STATE OF NORTH CAROLINA
DEPARTMENT OF TRANSPORTATION

Subject: DCM Consistency for the proposed US 70 Havelock Bypass in Craven County. TIP No. R-1015. WBS 34360.1.2.

The North Carolina Department of Transportation (NCDOT) submitted additional information on Havelock Bypass to you on March 13, 2020 for review in regards to the Division of Coastal Management's CAMA Consistency Determination for the project. This package included supplemental information and revised permit drawings. Based on further coordination with the NC Division of Water Resources, further revisions need to be made to this request. This letter is a revised version of the March 13, 2020 request, showing additional and modified information highlighted in red.

**PERMIT DRAWING
SHEET 17 OF 167**

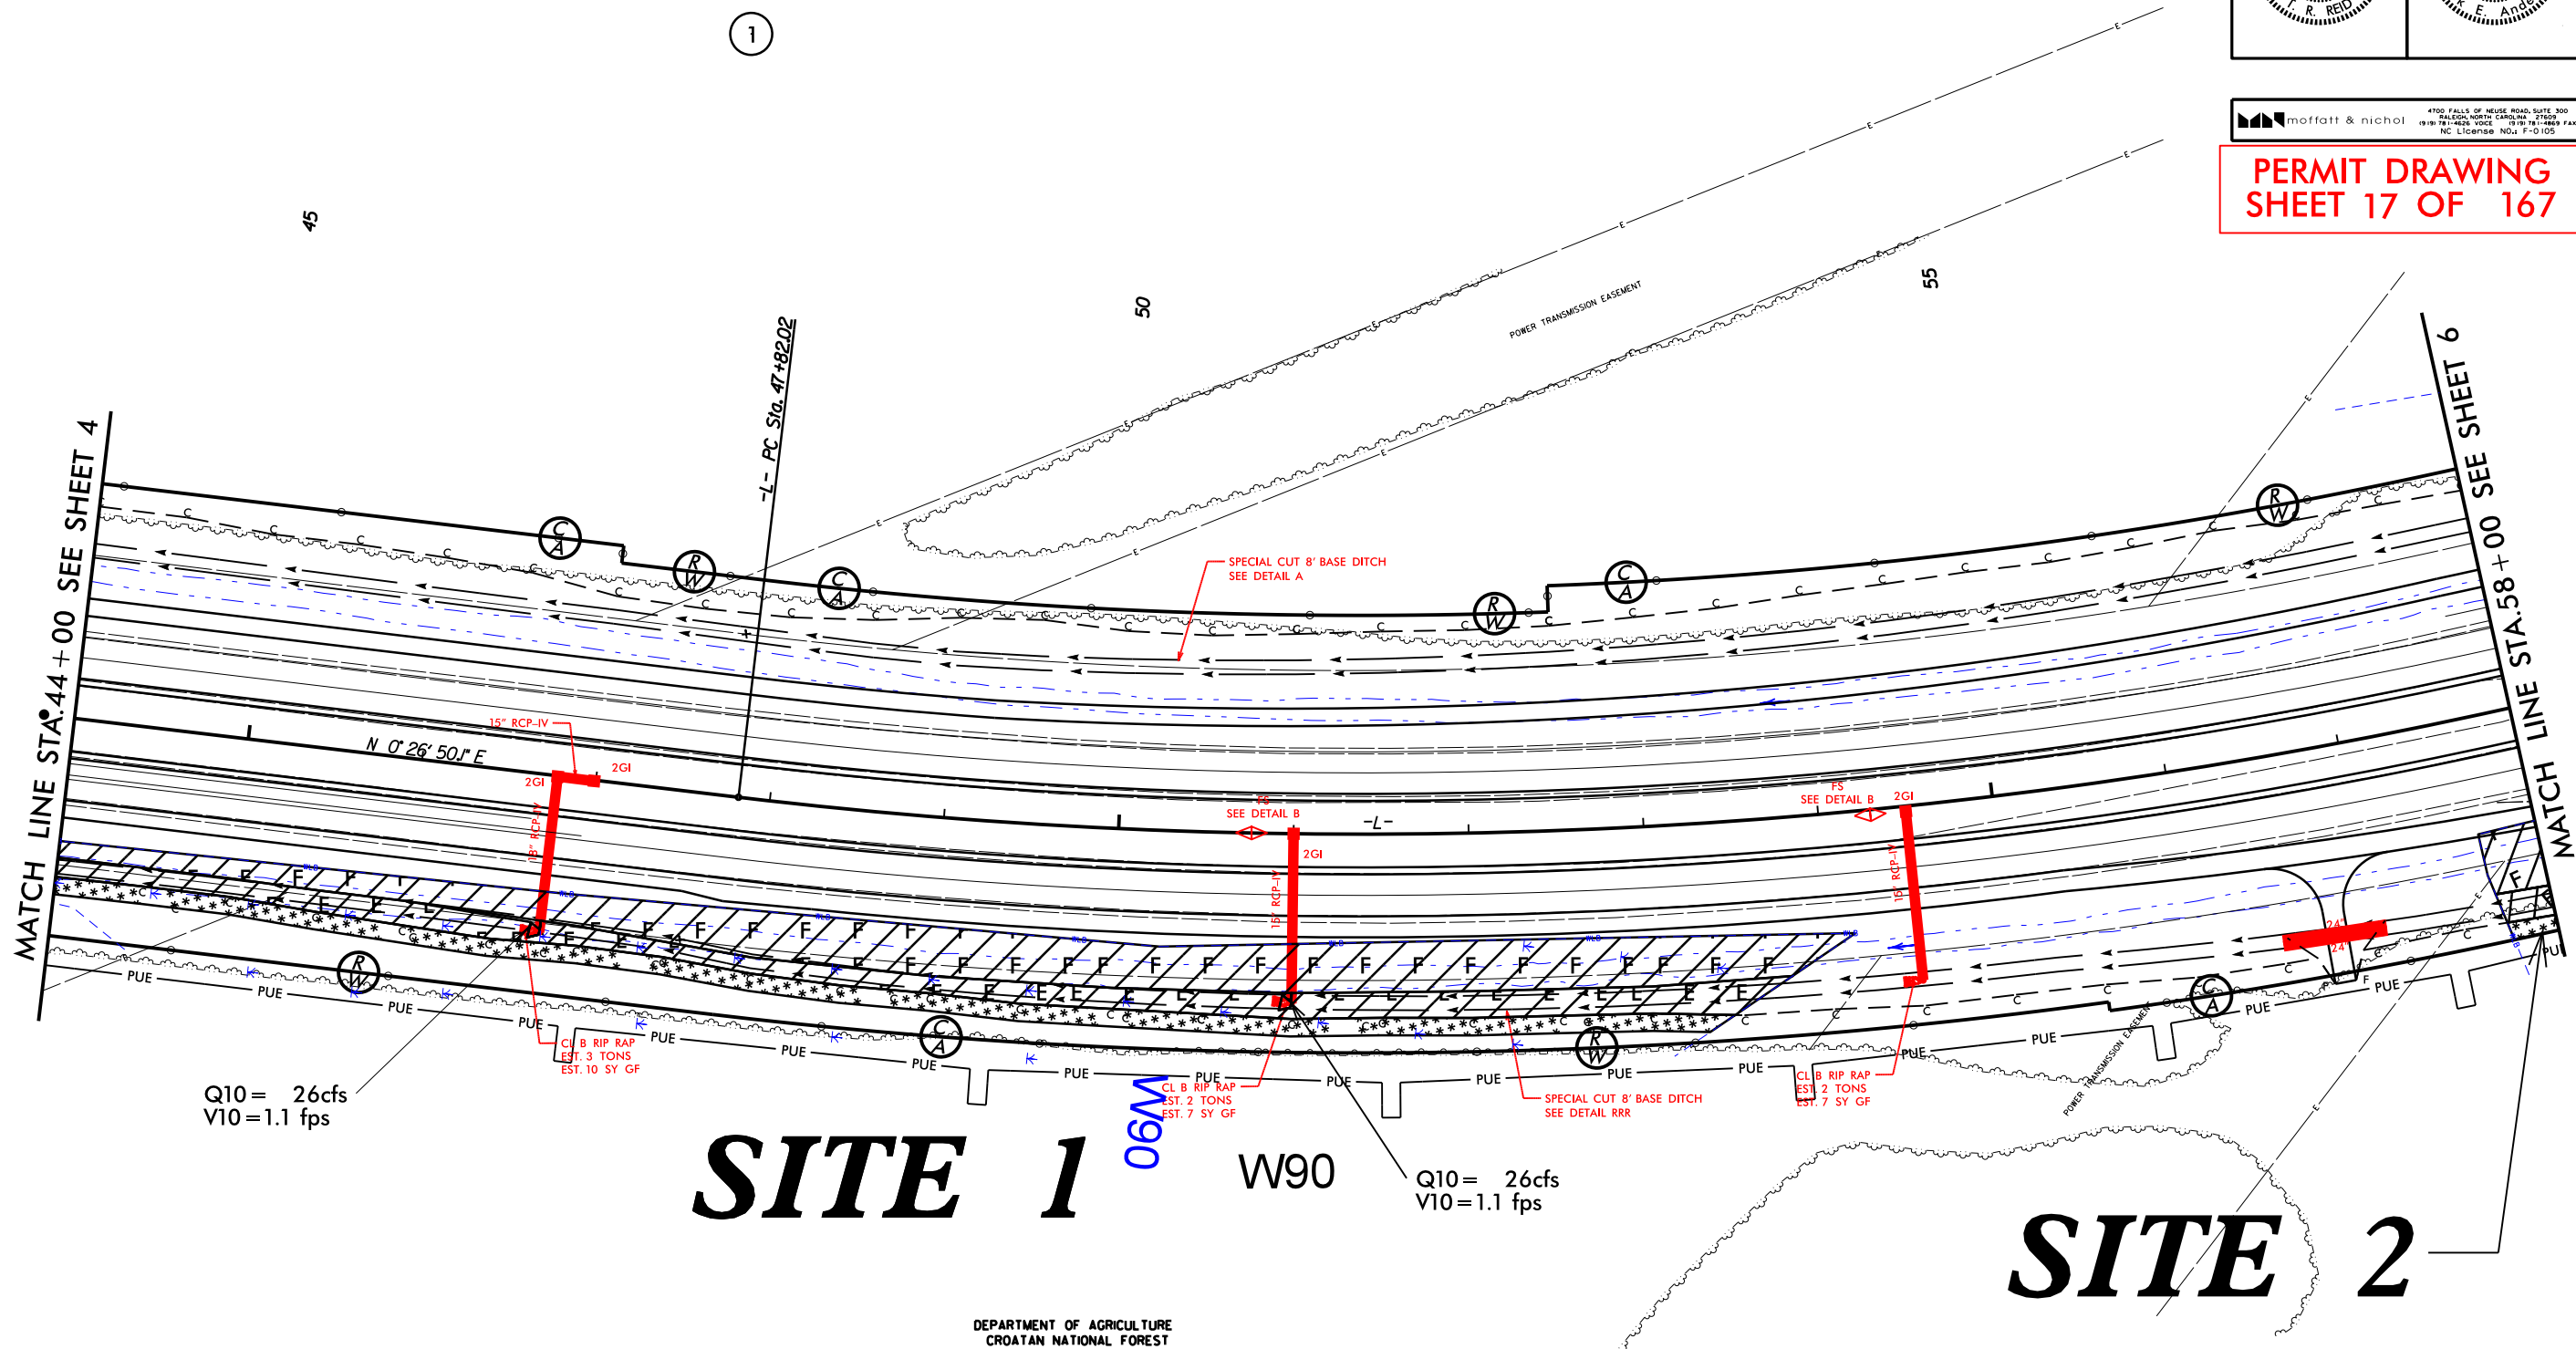
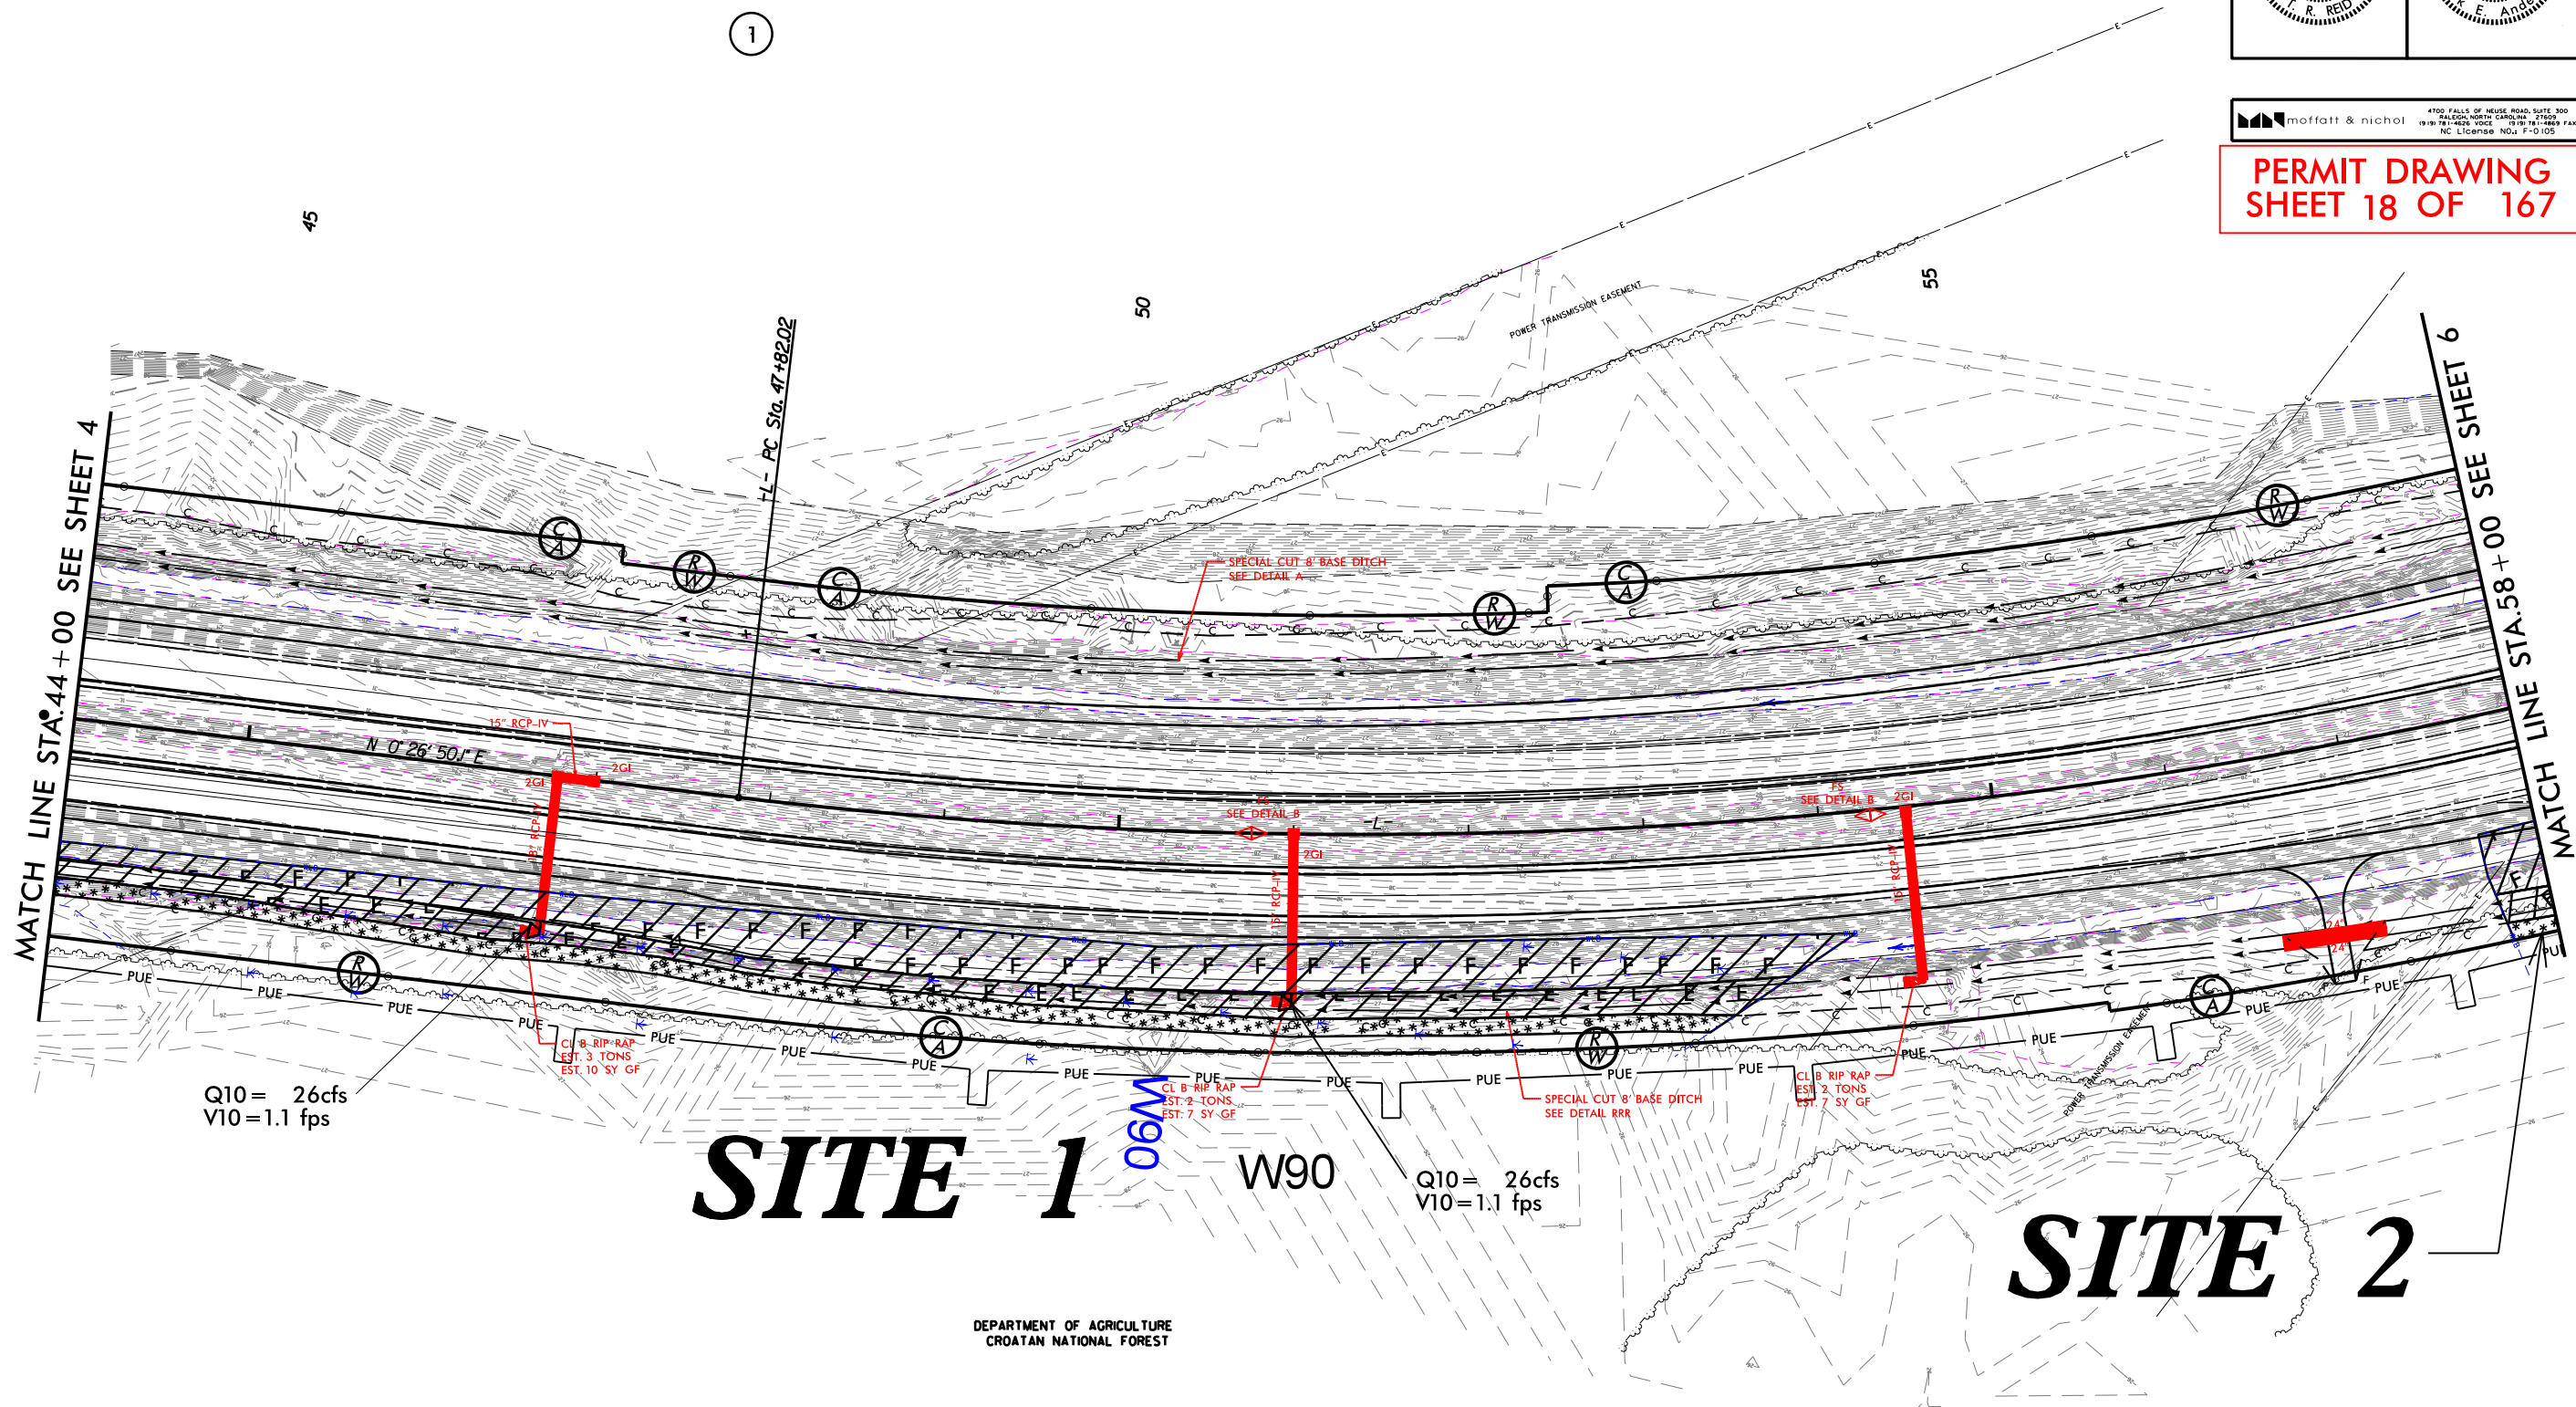
- Detail sheets updated (permit drawings 2 & 3)
- Site 1 (permit sheets 17&18) added riprap in the excavation area due to riprap pads at two pipes. A driveway was added, which did increase the impacts from fill, but decreased the mechanized clearing and excavation. The permitted total (1.16 acre) did not change.
